Continuous Quality Improvement

- Dialog+ SW 9.xx

• Front Panel Board FPB with Integrated Backlight Inverter Board BIB
1. Related Machines

Fig. 1: FPB with integrated BIB

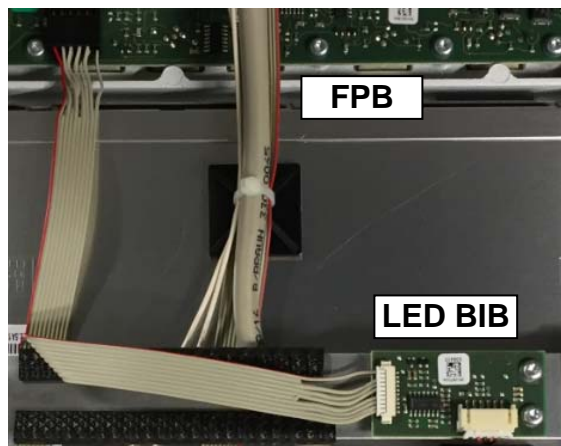
The front panel board FPB was modified and now has an integrated backlight inverter board BIB.

The front panel boards are not forward and backward compatible and the same type has to be used as spare part. All types of FPBs are still available depending on the BIBs present in the machine (see bottom figures).

Front Panel Board FPB	Backlight Inverter Board		
	Integrated BIB	LED BIB	High Voltage HV BIB
34562282 (from serial number 245466/313224/510431, see fig. 1)	X	-	-
34562176 (from serial number 219320/304481, see fig. 2)	-	X	-
3451428A (for SW 8.xx/SW 9.xx up to serial number 219319/304480, see fig. 3)	-	-	X
